CITY OF ALBUQUERQUE

**RE: Entertainment Facility
3930 Pan-American NE
Grading and Drainage Plan
Engineers Stamp Date: 2/16/18
Hydrology File: G16D145A**

**RE: ENTERTAINMENT FACILITY
3930 PAN-AMERICAN NE
GRADING AND DRAINAGE PLAN
ENGINEERS STAMP DATE: 2/1/18
HYDROLOGY FILE: G16D145A**

ENTERTAINMENT FACILITY
3930 PAN AMERICAN FRWY
GRADING PLAN

SECTION A-A

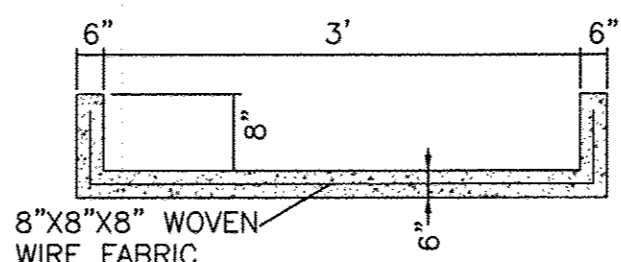
4. The southern drainage easement is currently being used for surface drainage. The construction plans for the drainage easement (SAD216 CPN: 3960) show an earthen drainage channel with cement treated base (CTB) dikes, a flow depth of 0.33', and a 48" storm drain beneath. The current proposal to use it as a first flush facility is unacceptable until it can be demonstrated that the new pond will not interfere with the function of this channel.

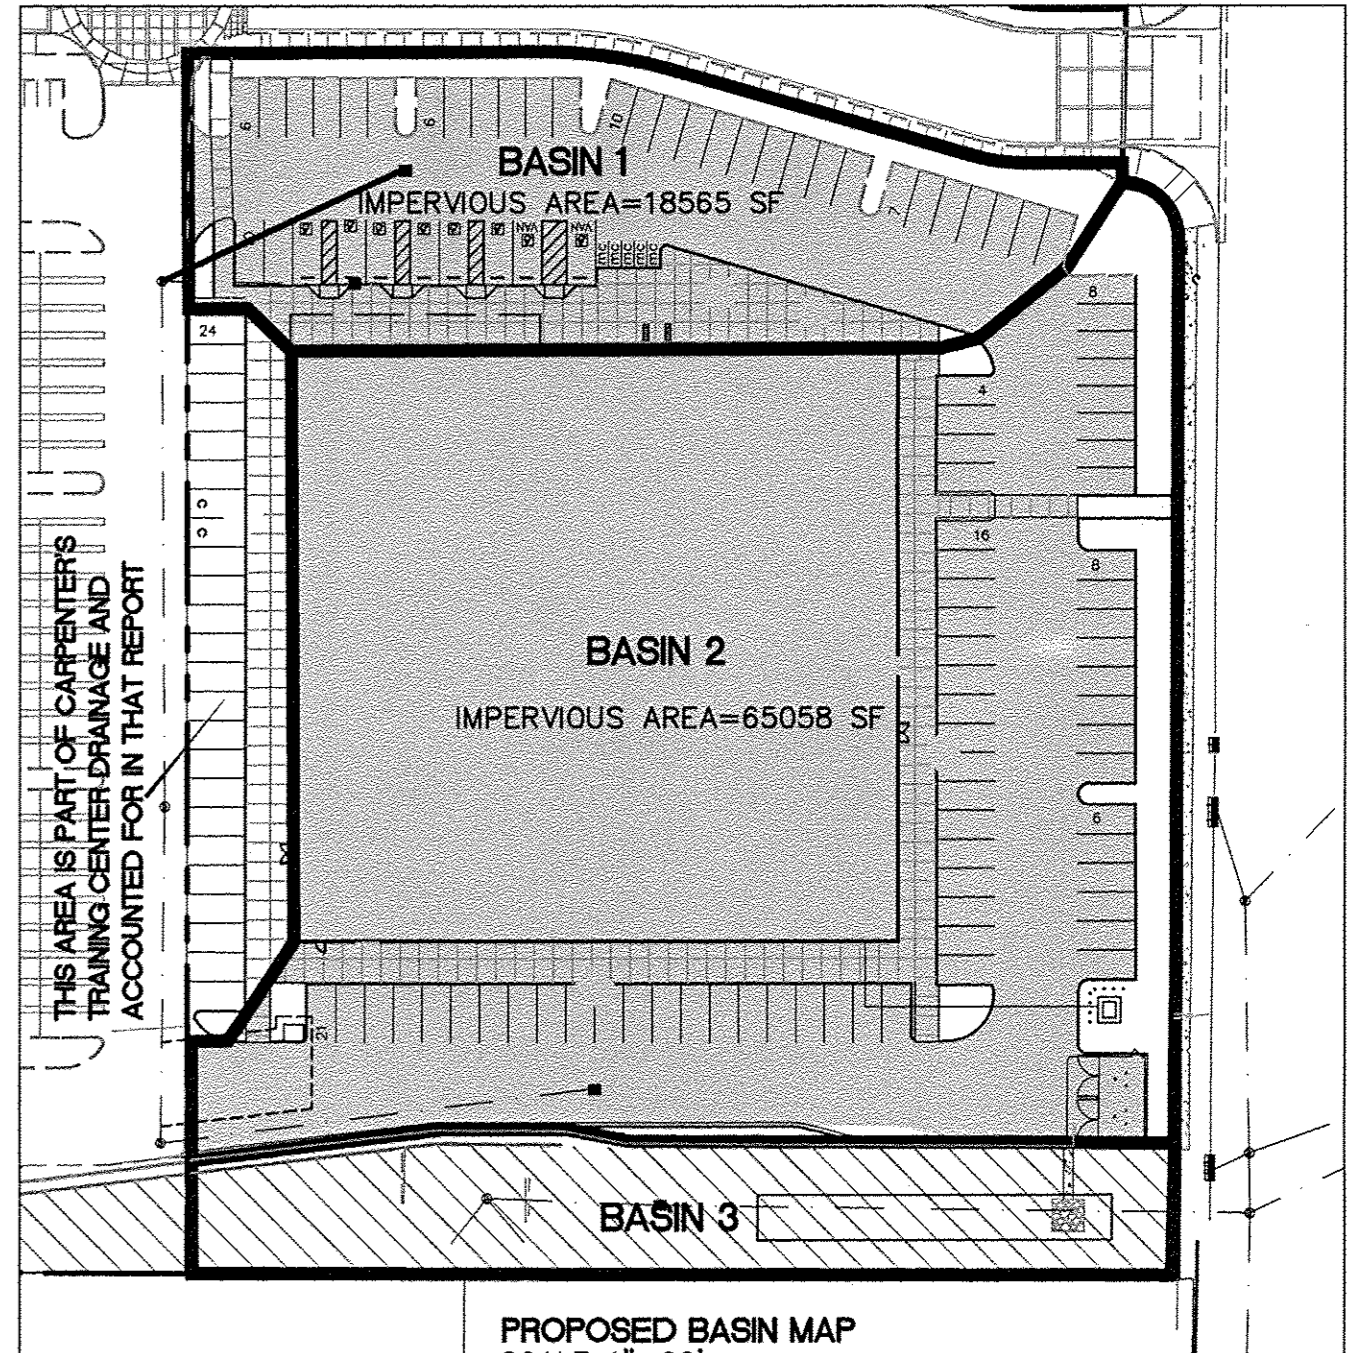
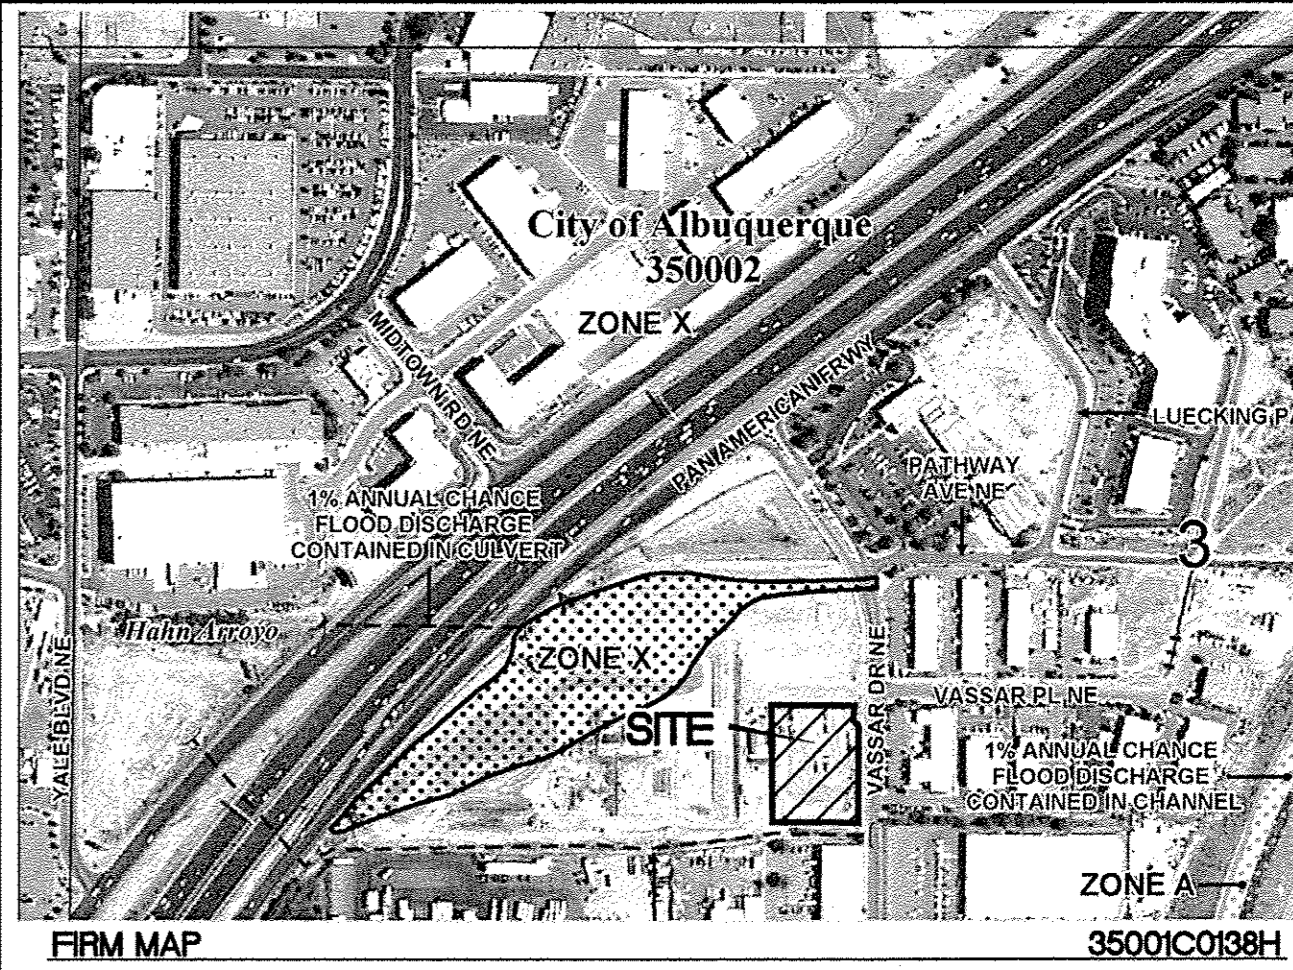
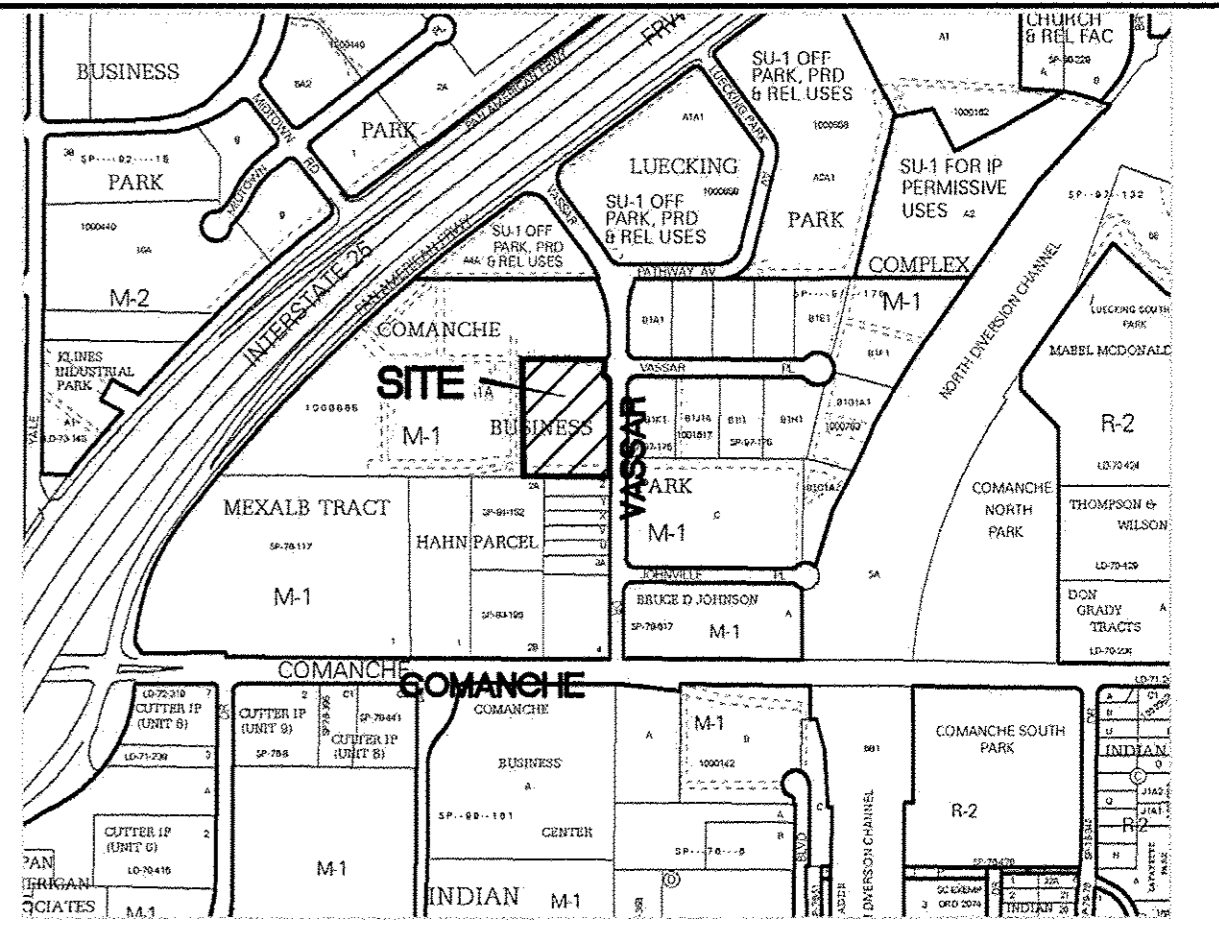
1. The first flush pond(s) need to be sized for the areas draining to them. Calculate the first flush requirement for each subbasin within the project site, including the western edge of this project site that is not delineated. Show how the first flush runoff will be retained on-site from each subbasin.

2. If unable to retain on-site, the runoff that bypasses the first flush ponds will need to be quantified and stated on plans.
3. Payment of Fee-in-Lieu will be required for the bypass volume at a rate of \$8/CF. this appears to be all of Basin 1 and the non-delineated western edge.

6. Additional detail will be needed for the pond(s), including top of pond elevations, actual and required volume and water surface elevations with respect to walls and property lines.

1. The western edge of this project site is no delineated as a subbasin and does not appear to be considered in your drainage plan. Please include.
The western edge of this project is accounted for in the original Carpenter's Center Master Drainage Plan and drains to an existing inlet in the parking lot to the west.

2. Hatch or otherwise delineate the impervious versus areas on the subbasin map and provide the areas for each. Include a scale for the subbasin map.
The Basin Map is now scaled and includes hatching for the impervious area as well as the square footage.

3. This site has been previously graded and compacted by human activity; no type B land treatment remains. Please update to reflect land treatment C.
Based on the definition in the DPM Type B is acceptable for irrigated lawns, parks and golf courses with flat slopes. This is the land treatment that is used for landscaped areas within the City. Type C is generally used when there are large slopes on the property, which this one does not have.

4. Calculate the first flush requirement for each subbasin and shoe how it will be retained on-site for each subbasin. If unable to retain on-site, the bypass volume needs to be quantified and stated on plans. Payment of Fee-in-Lieu will be required for the bypass volume at a rate of \$8/CF.
The First Flush calculation was completed for each Basin. The total volume is captured in the proposed First Flush pond located along the south property line.

5. Basin 2 is described as surface draining south into the drainage channel. However there is an existing inlet in the proposed parking lot that drains to the west. Will this be removed?

6. Who owns the southern drainage easement? Assuming this a publicly owned easement, the proposal to use it as a first flush facility is unacceptable and an alternate site needs to be selected for first flush ponding. The City will not accept maintenance responsibility for private first flush ponds.

The existing inlet was constructed with the original Carpenter's Training center prior to the First Flush requirement. This grading plan is set up to essentially bypass this inlet, although storm water may enter the inlet during large rain events.

The easement is a public storm drainage easement for the storm sewer and owned by the property owner for the site. The surface is still the responsibility of the owner of the property and they are the ones responsible for maintenance as part of the continuing responsibility for the property.
